UNECE EVE-IWG

In-Vehicle Battery Durability

OICA position on Part A and Part B Verification of Monitors EVE-IWG #51 08.-09.07.2021 Part A: Verification of Monitors

(current text)

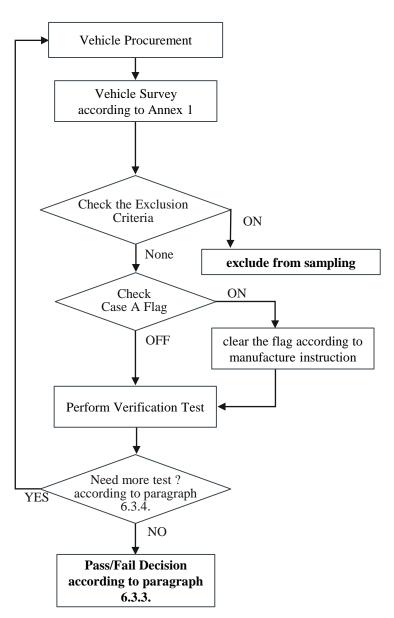
Improves accuracy of the SOCE value

- Concerns about systematic shift in SOCE upon clearing the Case A flag
- How will the Case A flag be displayed? Will it be visible to the consumer?

Supported by OICA

(no Case A flag)

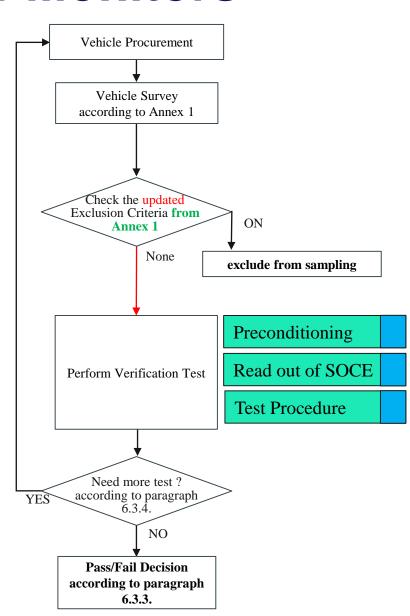
- Could the Annex 2 Case A criteria be moved to Annex 1 Vehicle Survey (exclusion criteria)?
- Annex 2 Case A:
 "The vehicle has not done a full charge-discharge cycle during the last month"
- Wording of criteria will need rephrasing / defining further

Acceptable for OICA with SOCE readout after preconditioning.

(USEPA, SOCE %var)

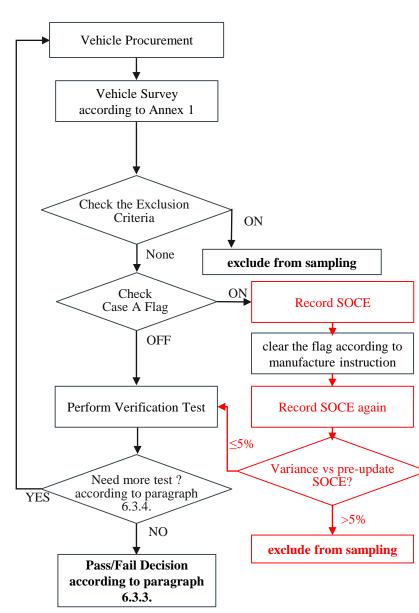
- Suggestion to record SOCE before and after VM update and have a permitted variance between values, e.g. 5%
- Is this double-counting 5% tolerances?

Not supported by OICA

Part B: Verification of Battery Durability (current text – no Case B flag)

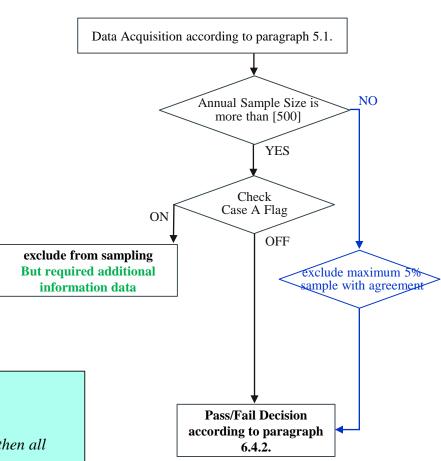
- Ensures accuracy of the SOCE value
- Concern that large number of Case A flags could be excluded
- Concern that poor performing vehicles may be hidden by Case A flags

Supported by OICA

No Case B flag:

The following sentence to be added to paragraph 6.4.1.:

If the number of vehicles in the sample is equal or more than 500, then all vehicles shall be included in the sample.

Vehicles that have not been properly maintained may be excluded from the sample regardless of sample size. Evidence shall be provided to the responsible authority.

Part B: Verification of Battery Durability (no flags)

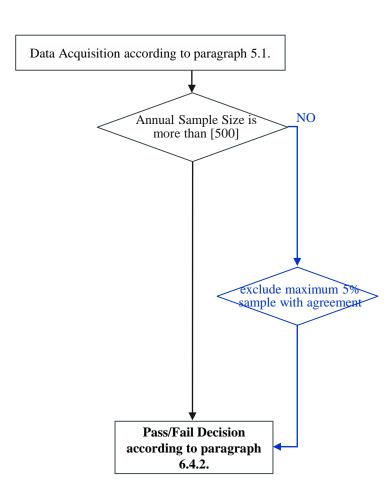
• To be discussed

If no Case A flag → further discussion required about possible solutions within IWG EVE

Part B: Verification of Battery Durability (JPN, record flag data)

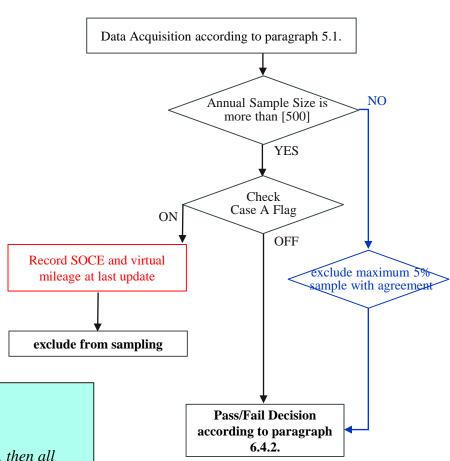
- By recording SOCE/virtual mileage even when Case A flag is on, possible to probe the data to detect potential misuse
- Where is the data being recorded? Who is monitoring the data for misuse?
- Concerns whether action could be taken if misuse was detected

Acceptable for OICA

Part B: Verification of Battery Durability (USEPA, fail on % flags)

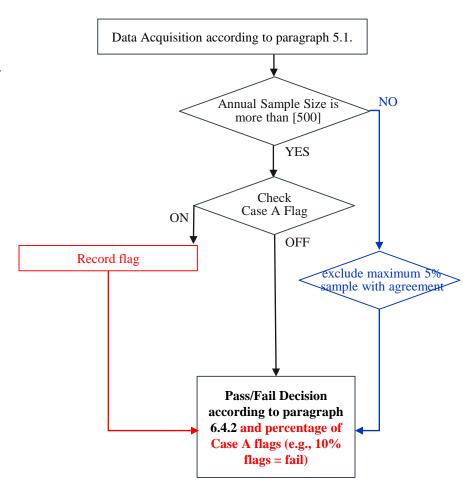
- Removes incentive to deliberately raise Case A flag by including them as a possible failure criteria
- What percentage would be used as a failure?

Not supported by OICA

Part B: Verification of Battery Durability (hybrid of JPN/USEPA)

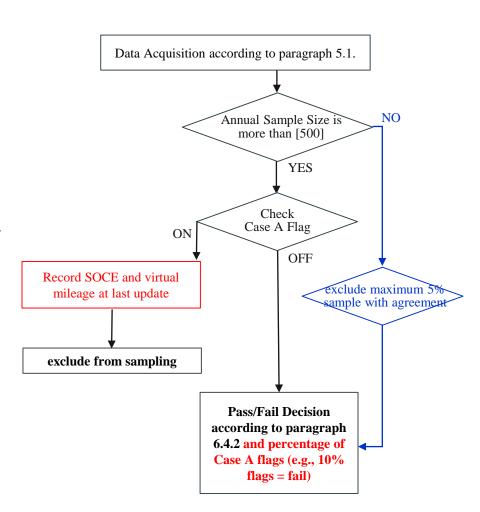
- As in JPN's proposal, if Case A flag is on, SOCE and virtual mileage at last update is recorded, but vehicle is excluded
- However, USEPA proposal of failing on % flags still applies, removing incentive to deliberately raise flag
- What percentage would be used as a failure?

Not supported by OICA
